Your ref:
Our ref: 613626605

18 June 2021

Surface water hydraulic structure vegetation impacts

ROY HILL IRON ORE
Section 38
 Surface Water Hydrology
MINE CLOSURE
HYDRAULIC STRUCTURES
ORIGINAL AND PROPOSED

Original Proposal Hydraulic Structures

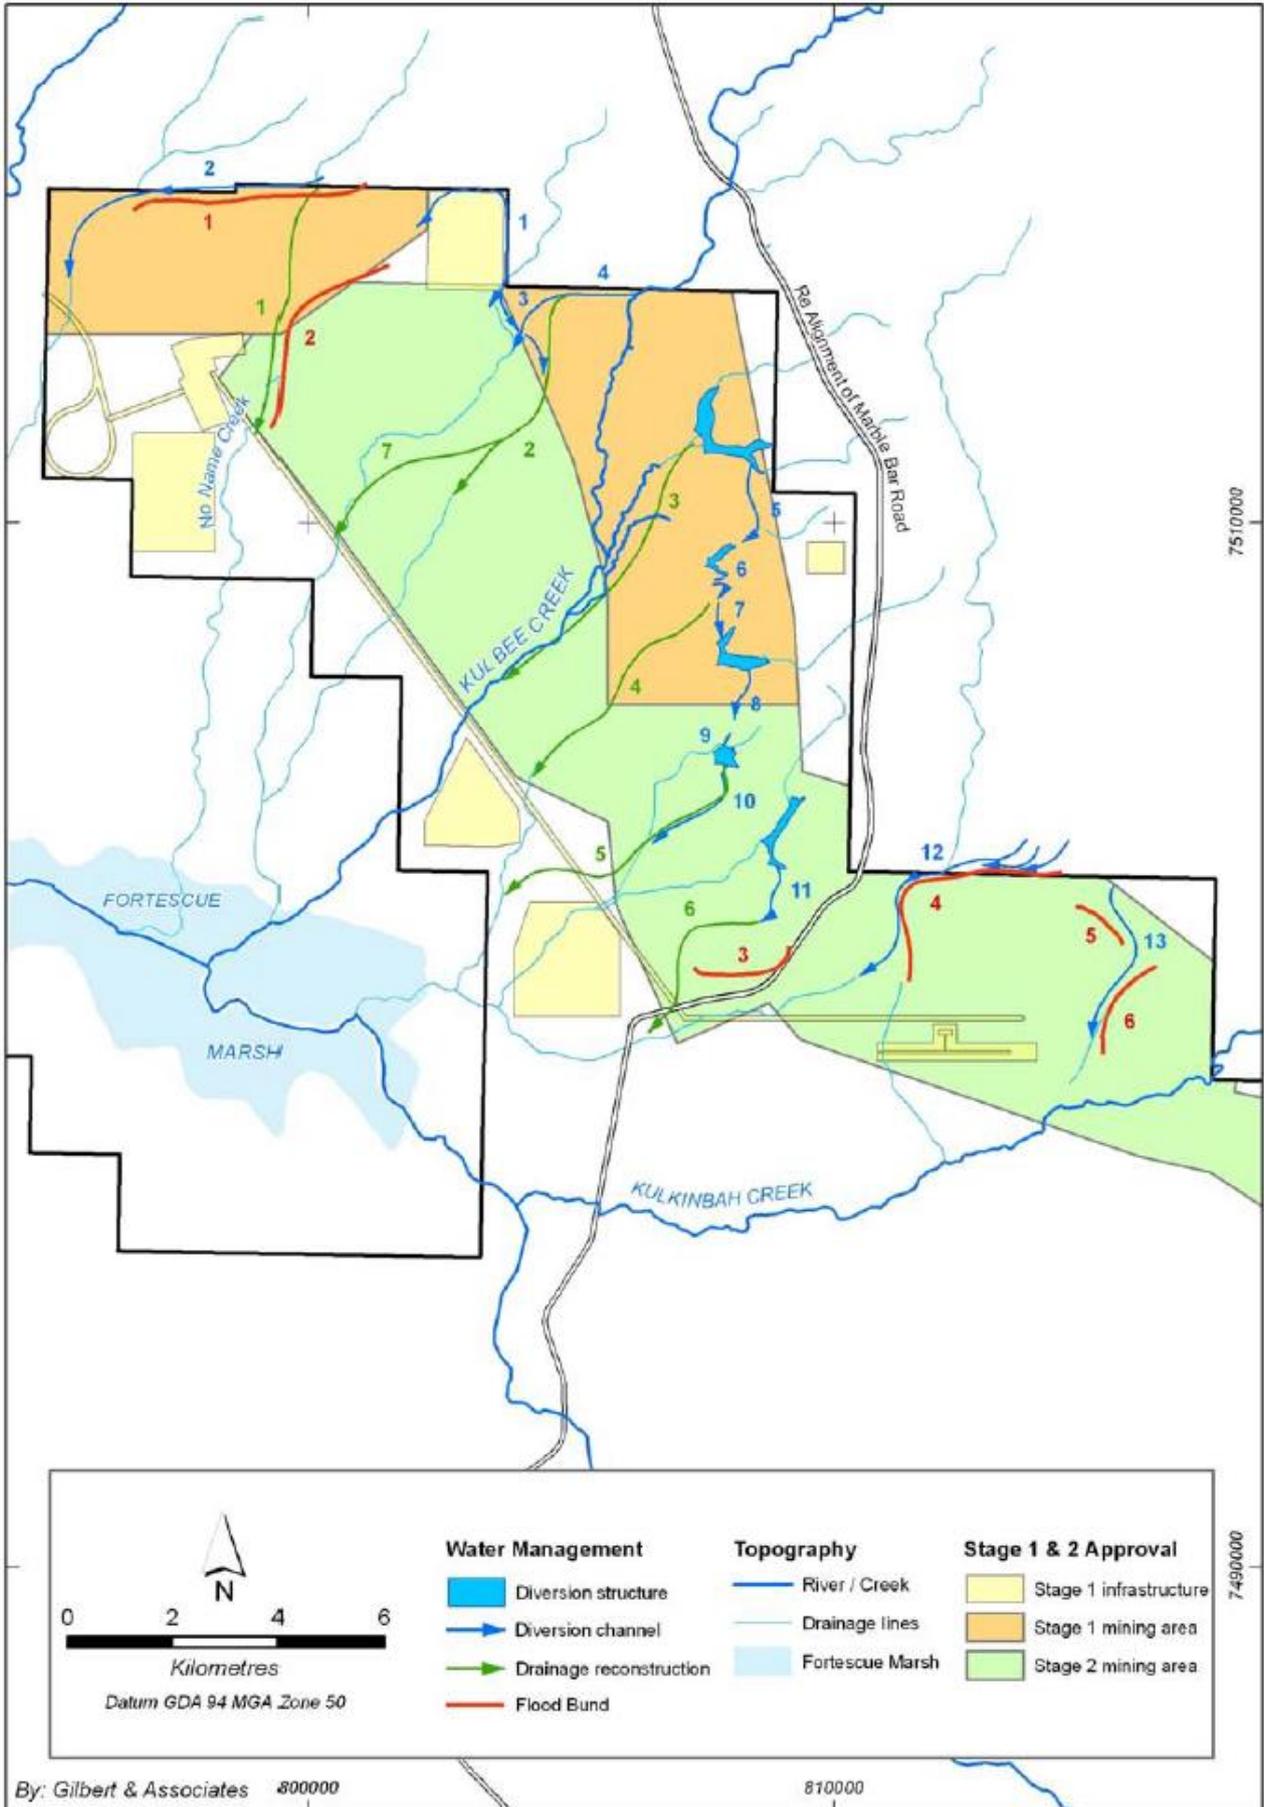
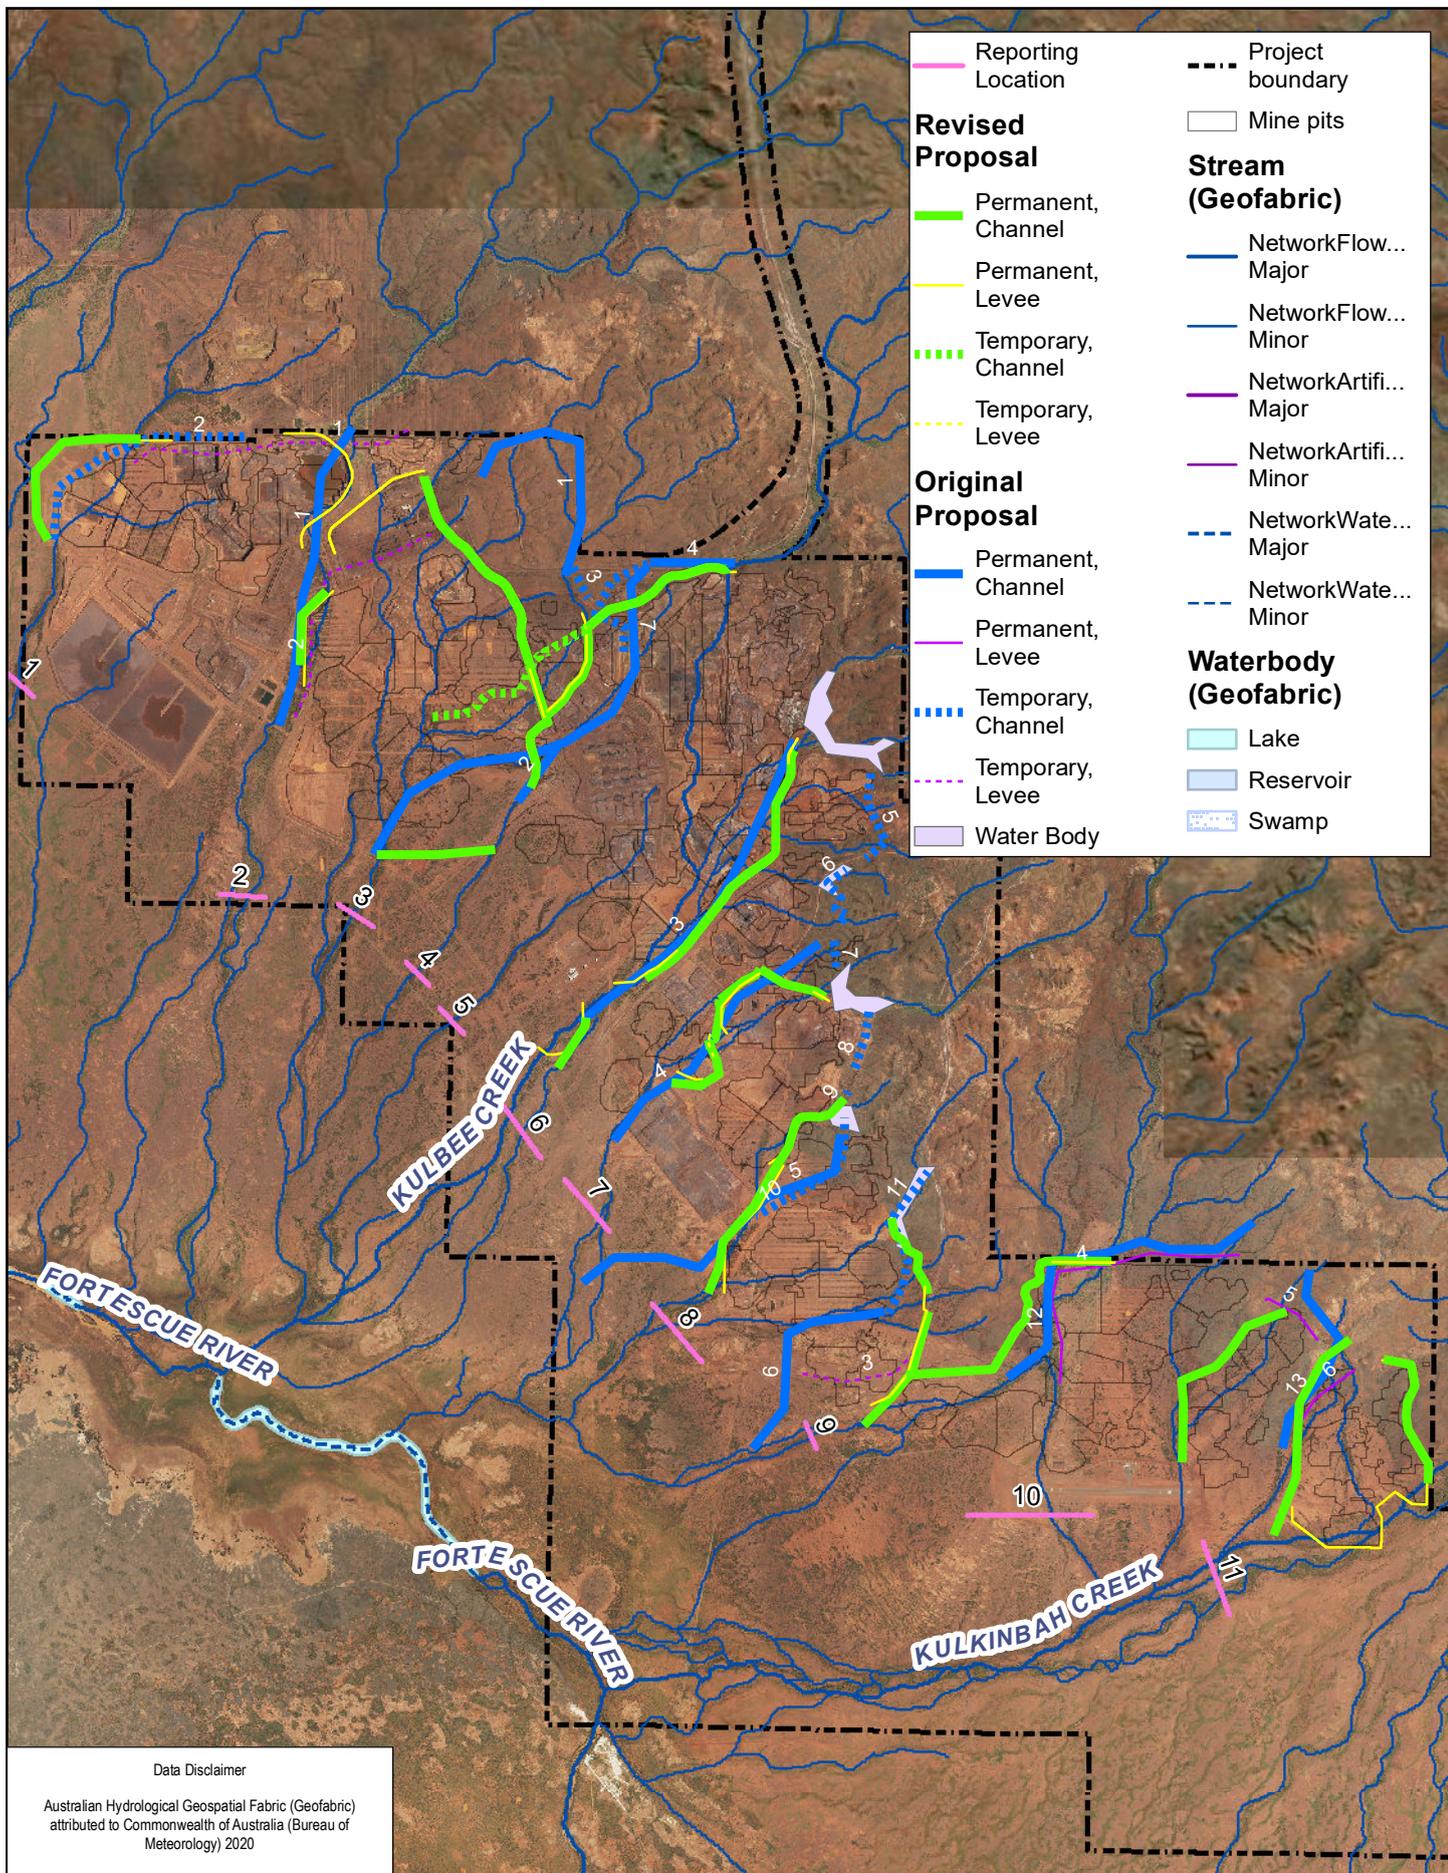
The Original Proposal presented 31 hydraulic structures to collect, store, convey, and discharge surface water for the purpose of enabling mining activities whilst maintaining flow into the Fortescue Marsh. There was a combination of temporary and permanent structures, including structures retained or reconstructed for mine closure. The structures are illustrated and described in Attachment 1.

FIGURE 1

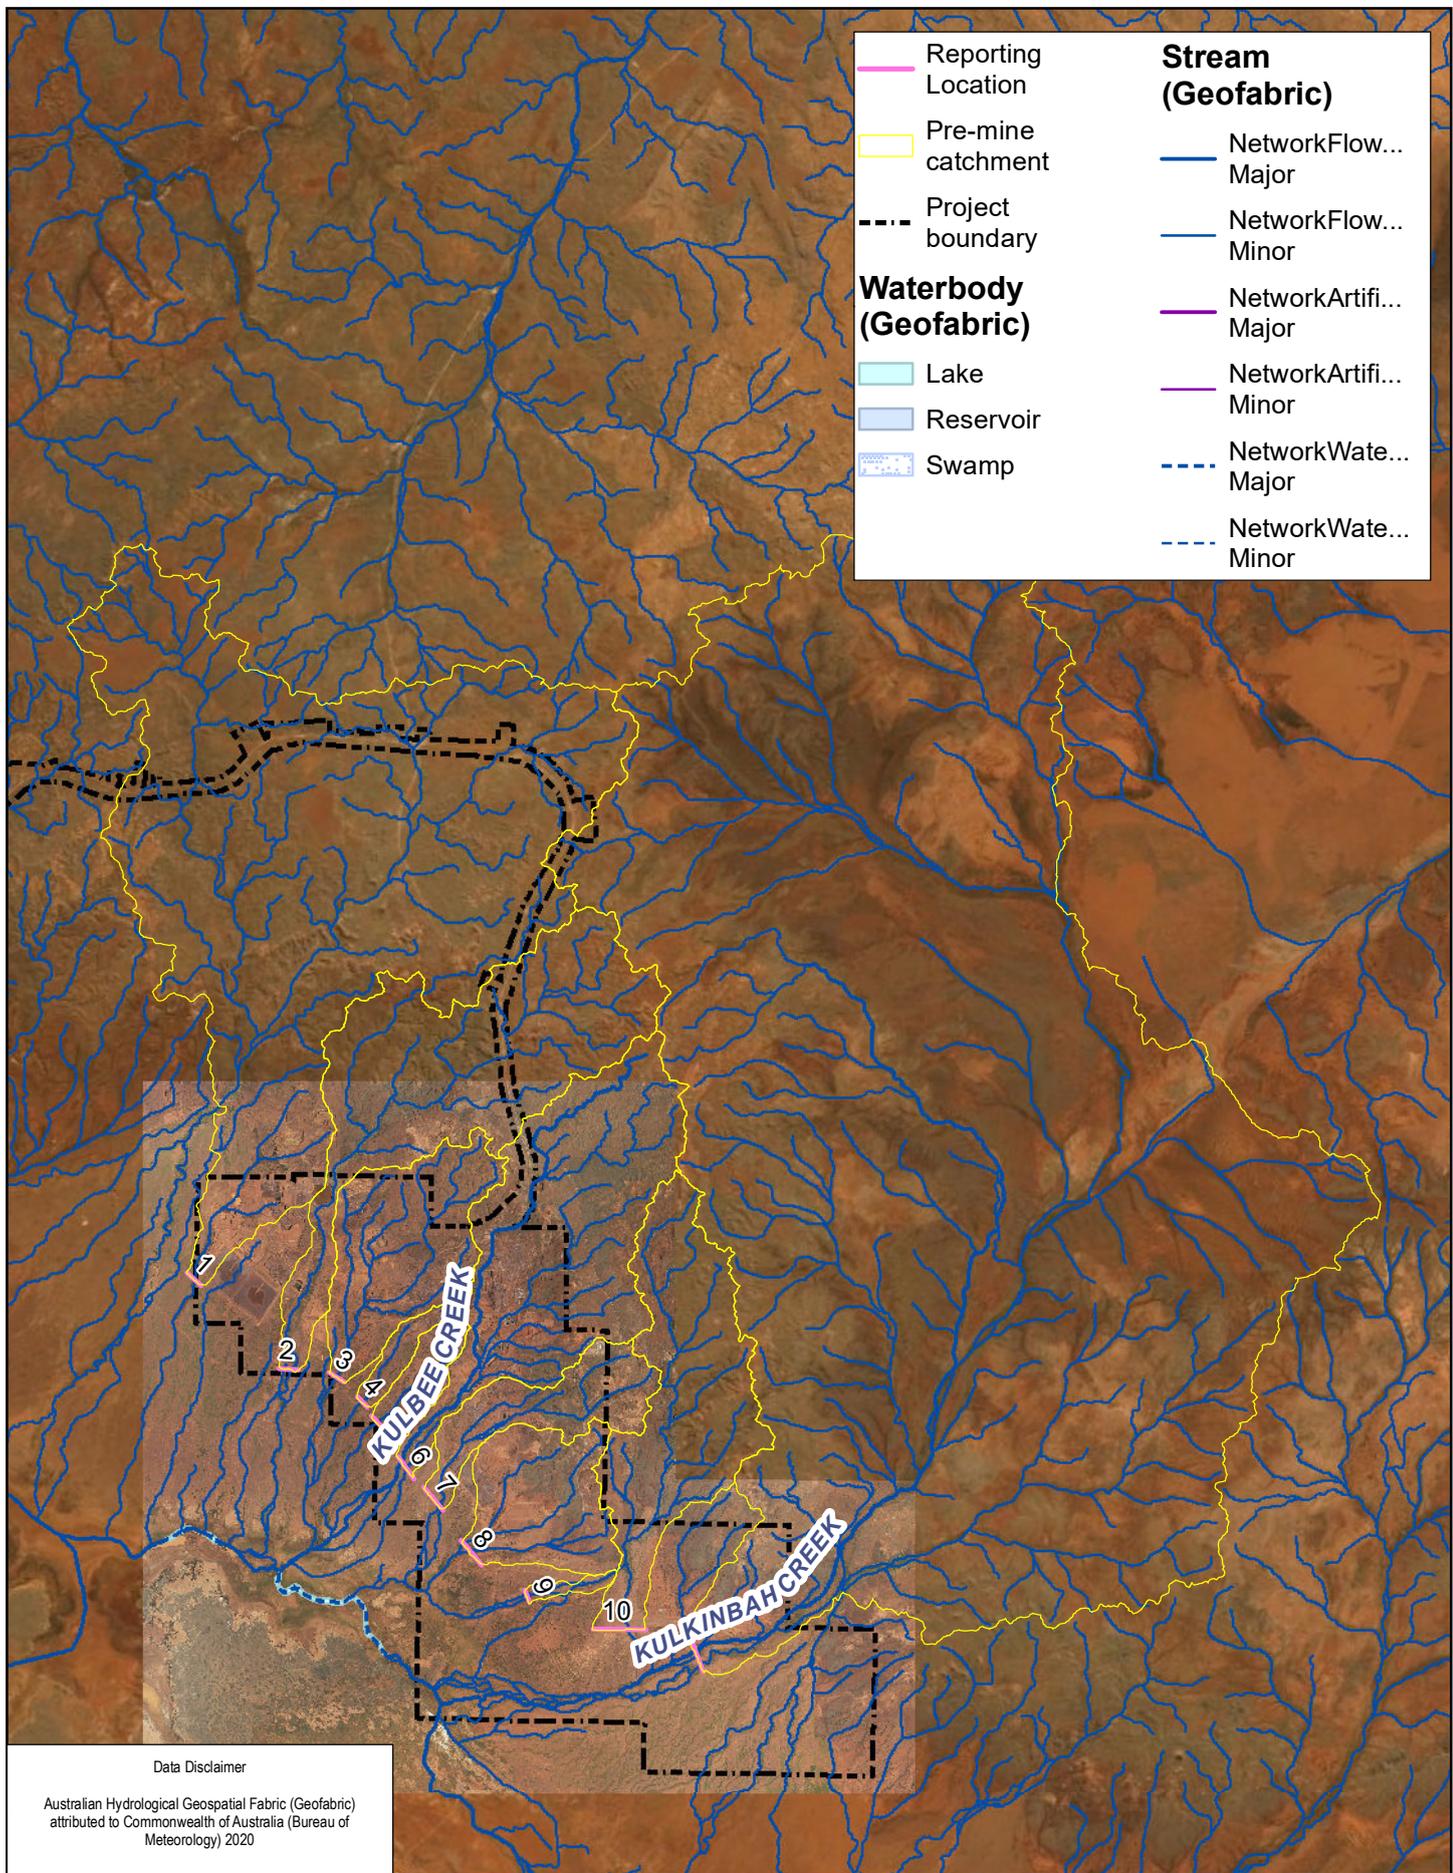
Original Proposal Structure	Revised Proposal
Diversion channel 1	No longer required
Diversion channel 2	Retained. Same function, alignment refined, now permanent
Flood bund 1	Retained. No longer diverts No Name Creek, shortened to suit Diversion Channel 2, now permanent
Diversion channel 3 and 4	Retained. Channel 3 relocated further to the west and lengthened. Channel 4 realigned to avoid mine pits
Drainage reconstruction channel 1	Reconstruction no longer required as original creek largely retained. Minor deviations to creek alignment to protect pits from flooding.
Flood bund 2	Retained. Realigned to suit mining activities, now permanent.
Temporary diversion channel 5 and associated diversion structures	No longer required, to avoid construction of cascading structures
Drainage reconstruction channel 2	Retained.
Temporary diversion channel 6 and associated diversion structures	No longer required, to avoid construction of cascading structures

Temporary diversion channel 7 and associated diversion structures	No longer required, to avoid construction of cascading structures
Drainage reconstruction channel 3	Retained.
Temporary diversion channel 8 and associated diversion structures	No longer required, to avoid construction of cascading structures
Temporary diversion channels 9 and 10 and associated diversion structures	No longer required, to avoid construction of cascading structures
Temporary diversion channel 11 and associated diversion structures	No longer required, to avoid construction of cascading structures
Flood bund 3	Retained and now permanent. Realigned to suit pits
Drainage reconstruction channel 4	Retained
Flood bund 4	Retained
Permanent diversion channel 12	Retained and lengthened to suit pits
Flood bund 5 and 6	Bund 5 abandoned in favour of a permanent diversion channel that returns flow to same stream. Bund 6 no longer required, replaced by a permanent diversion channel providing same function.

Permanent diversion channel 13	Retained
Drainage reconstruction channel 5	Retained but truncated to return flow to same waterway
Drainage reconstruction channel 6	Retained but realigned to suit pits
Drainage reconstruction channel 7	Realigned to avoid pits and reinstate flows to the stream that discharges to Reporting Location 3
[Not identified in Original Proposal]	New permanent flood bund at Kulkinbah Creek (reporting Location 11). Flow returned to same stream.
